ALA MOANA CANAL

REVISED

ENVIRONMENTAL

ALA MOANA PARK DRAINAGE CANAL

ALA MOANA PARK DRAINAGE IMPROVEMENT
FIGURE 3
FLOOD AREA MAP
SCALE: 1" = 1000'

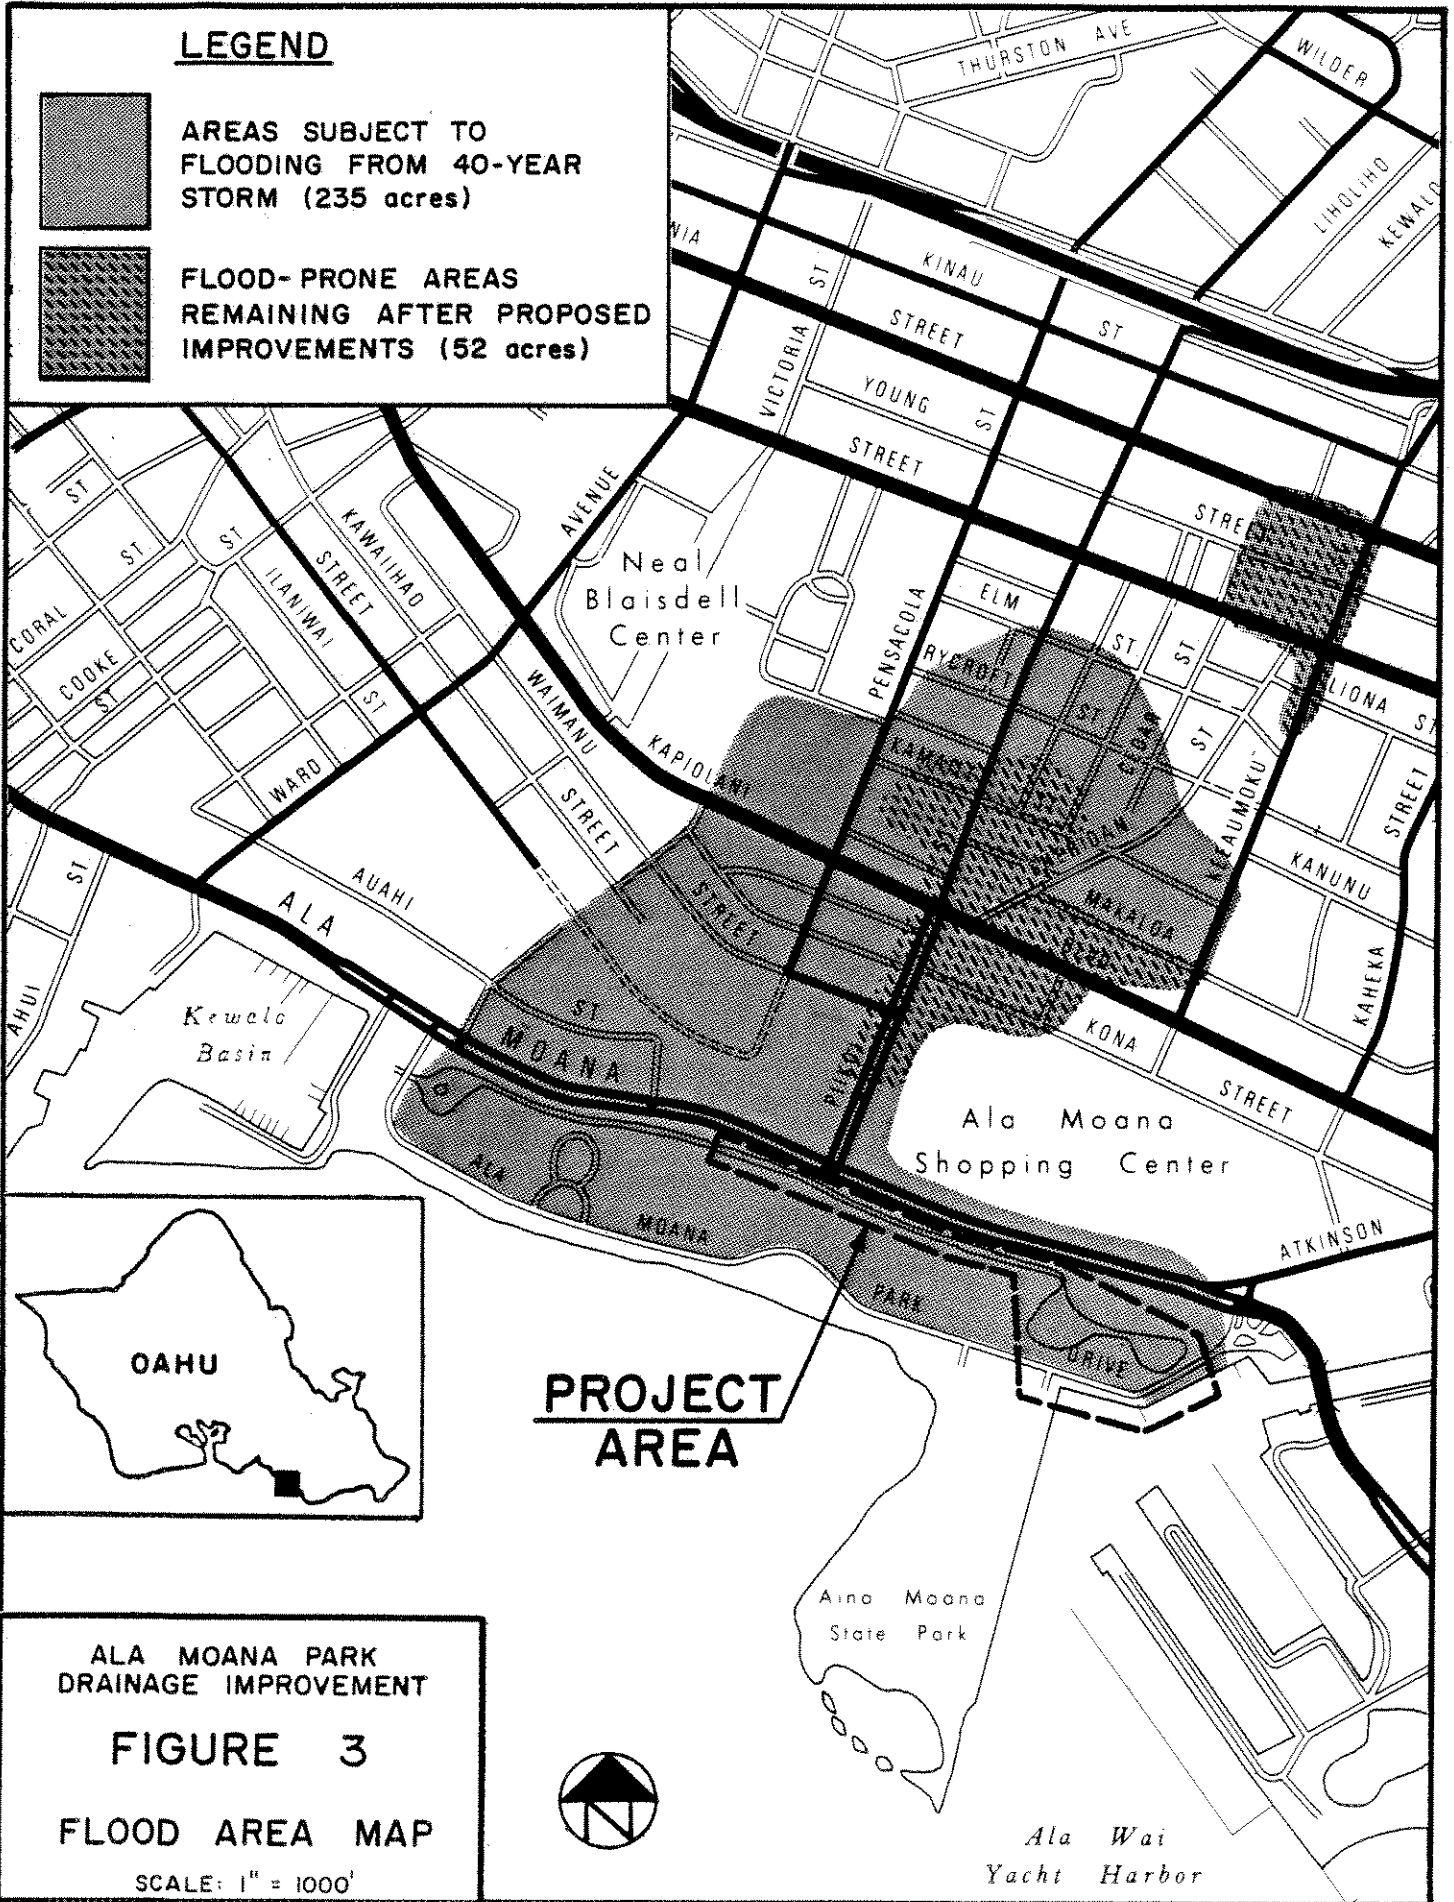
Areas Subject to Flooding. Figure 3 (p. 5) shows "Areas subject to flooding from 40-year storm (235 acres)" and "flood-prone areas remaining after proposed improvements (52 acres)". The latter category includes areas at the intersection of Piikoi Street and Kapoleiani Boulevard, and at King and Keeaumoku Streets. Some discussion of what action would be required to alleviate flooding at these busy intersections might be appropriate, perhaps in the alternatives section (Chapter IV).

ALA MOANA PARK
DRAINAGE IMPROVEMENT
FIGURE 4
PROJECT AREA
SCALE: 1" = 80'

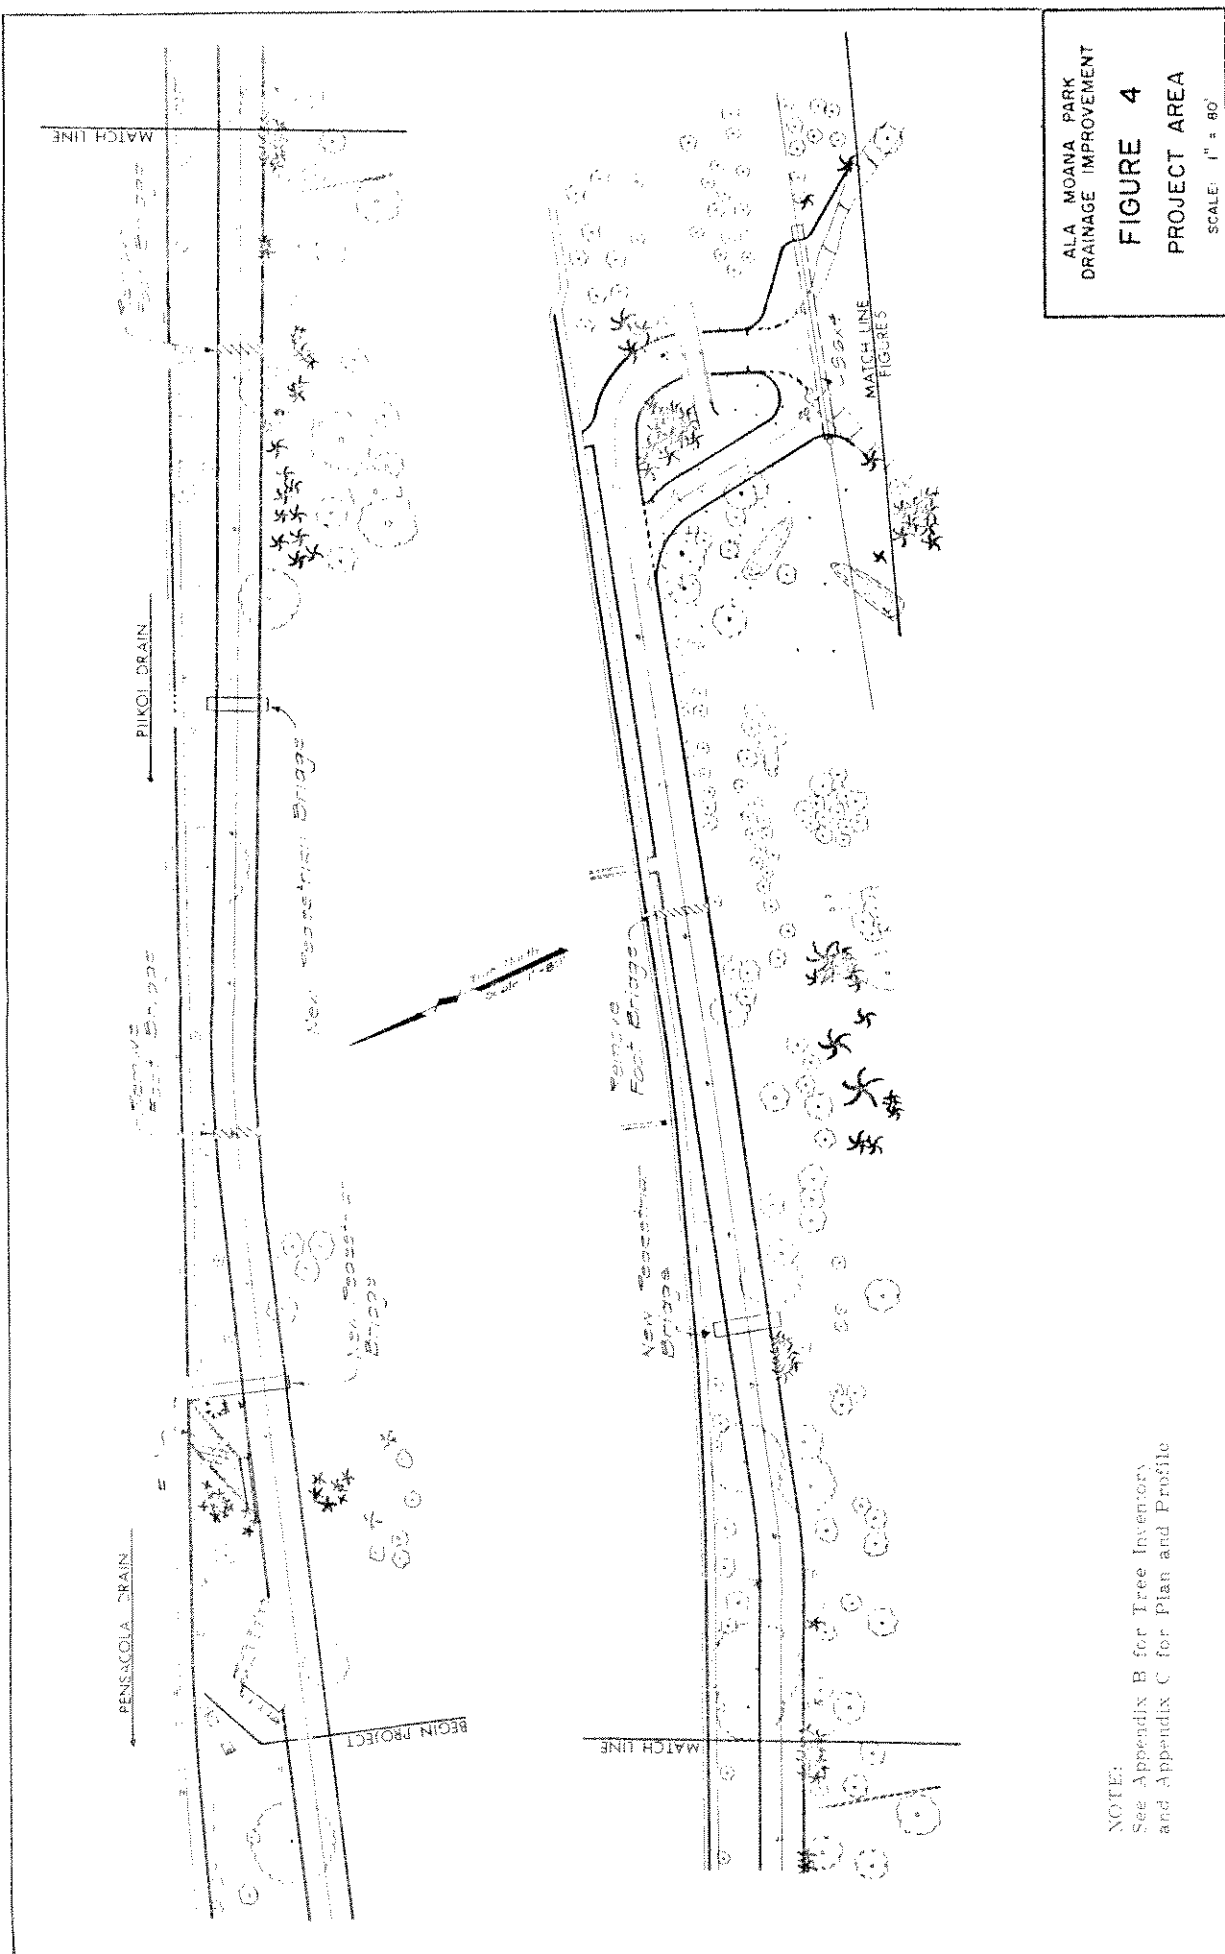
On page 6, Figure 4, an island is indicated in the first of the Diamond Head lagoons, but is missing in the enlargement of the inset. Are there any plans to flood or remove this island during the proposed canal improvements?

FIGURE 6
NEW CANAL AND
OUTLET CHANNEL
TYPICAL SECTIONS
NOT TO SCALE

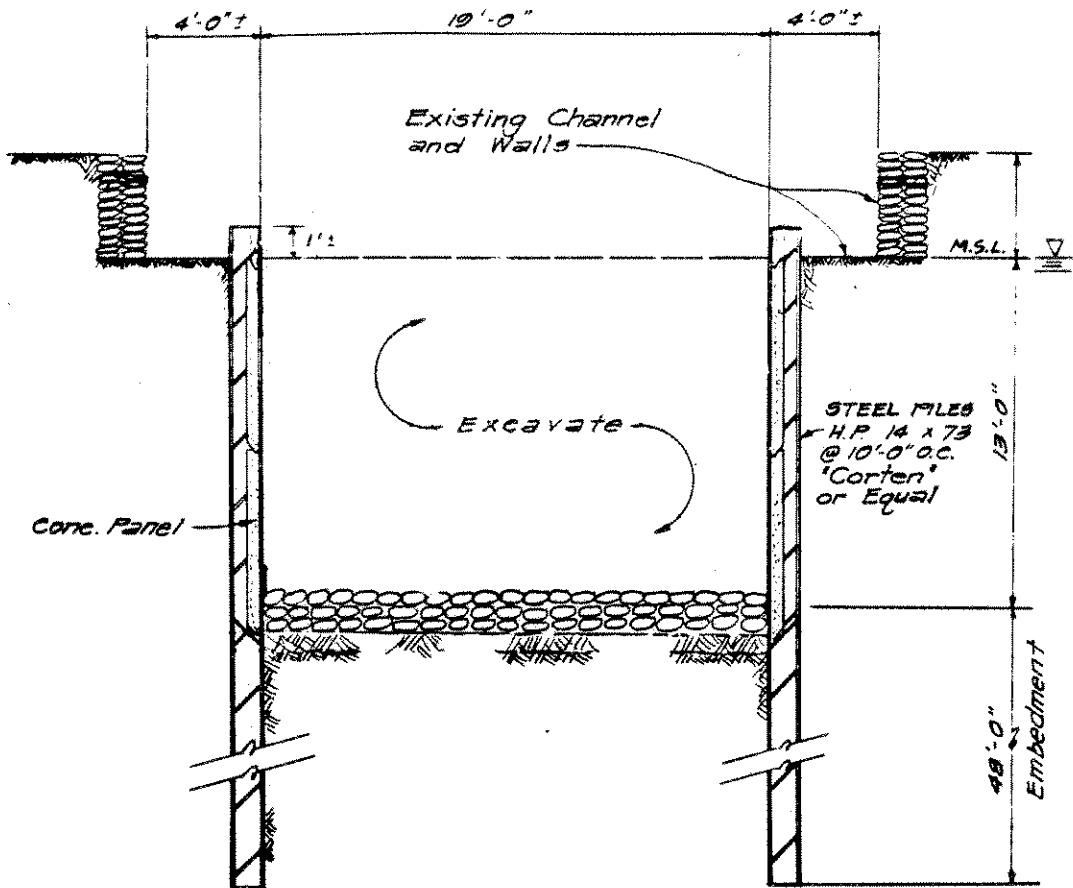
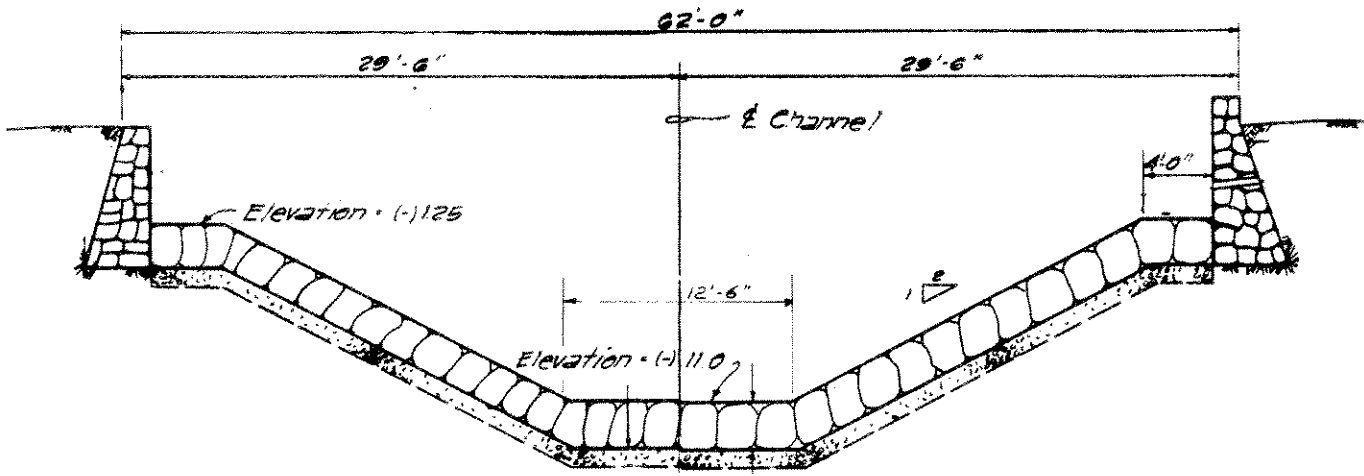
1. The key weakness in the proposed canal improvement is the deep channel excavated below mean sea level (msl).
2. It is very doubtful that the proposed 19 x 13 ft. excavated channel will provide enough additional storm drainage capacity because the channel will be filled at all times by msl water.
